DOMINION VIRGINIA POWER
NORTH ANNA UNIT 3 COMBINED LICENSE APPLICATION
SRPs 09.02.01 and 09.03.04: RESPONSE TO RAI LETTER 65

RAI 5554, Question 09.02.01-14

RAI NO.: 5554 (RAI Letter 65)

QUESTION NO.: 09.02.01-14

Figure 1

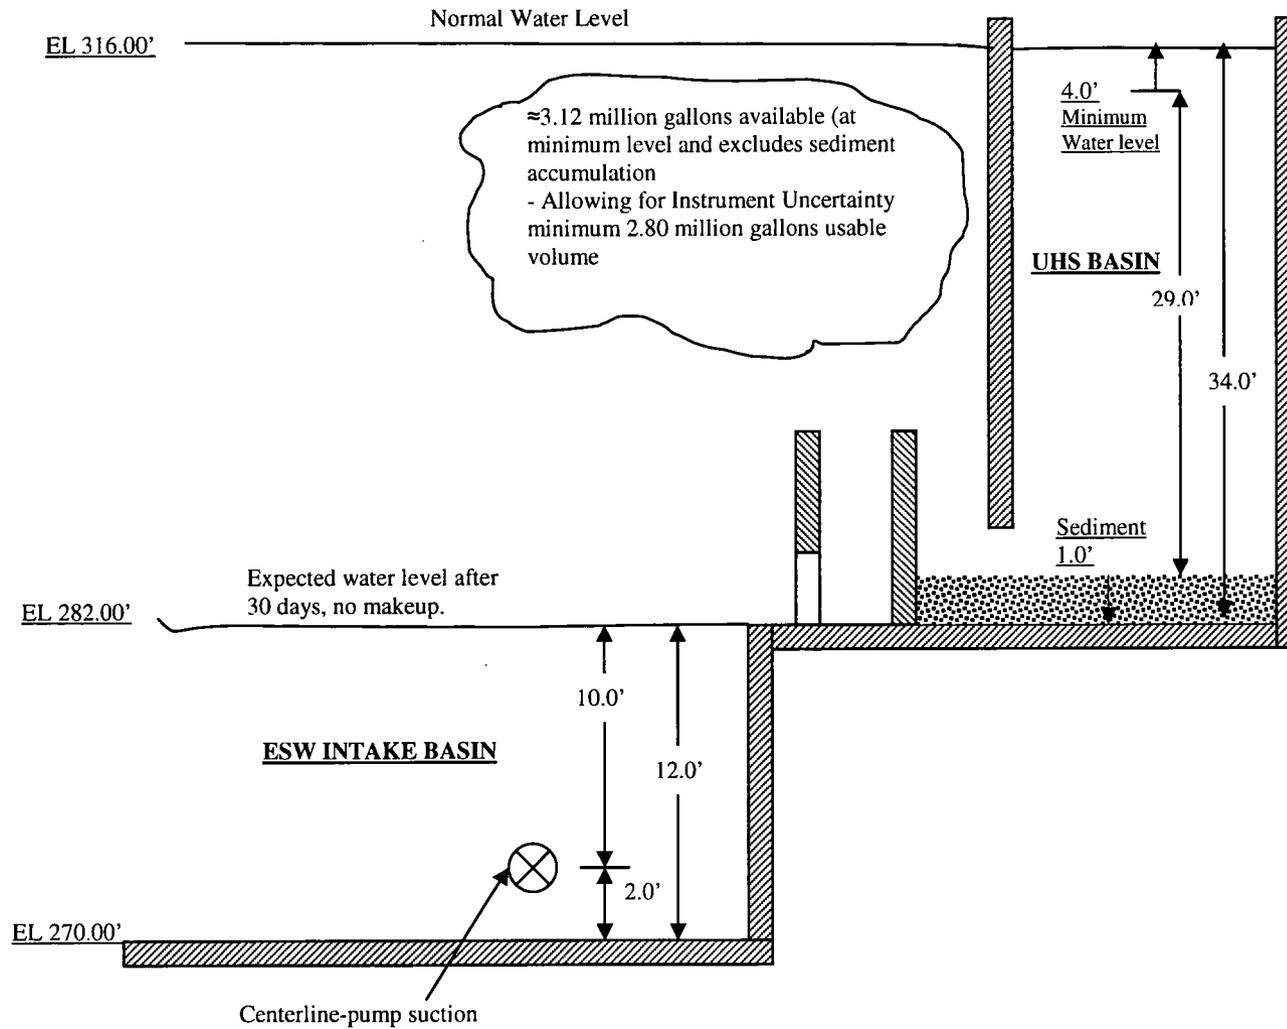
- Discuss pump vortex formation as part of the NPSH evaluation.
- Provide drawings indicating the elevation of the ESWS pump impellers.

- Provide a clarification to the following FSAR sections related to basin level to support NPSH. FSAR Section 9.2.1.2.2.1, "ESWPS" describes the available NPSH with the lowest expected water level (after 30 days of accident mitigation) in the basin to be approximately 12.2 meters (40 feet). However the UHS basin level is described as 8.8 meters (29 feet) deep in FSAR Section 9.2.5.3, "Safety Evaluation".
- Provide in the FSAR the bases for the ESWS pump total dynamic head (TDH) of 67.1 meters (220 feet) and describe the margins available for the pump as related to system losses. Include in the FSAR a discussion related to TDH, flow requirements and time durations to the fire protection system that supports the reactor building and essential service water pump house.

- The attached Figure 1 depicts the cooling tower basin structure elevations of interest including the ESW pump impeller. The ESW intake basin floor elevation is 270 feet and the UHS basin floor elevation is 282 feet. The normal operating water level is 316 feet. The minimum operating water level is 312 feet. The impeller (eye) of the ESW pump is located approximately 2 feet off of the ESW intake basin floor at an elevation of 272 feet. A vaned basket is installed at the suction of the vertical ESW pump. The actual ESW pump impeller elevation is subject to the final design details.

The 29 feet water depth in the UHS basin described in FSAR Subsection 9.2.5.3 is used to calculate available usable water volume (allowing for sedimentation and measurement uncertainties) from the low water level alarm point. Figure 1 provides the elevation and sediment information to illustrate the 29 feet water level in the UHS basin.
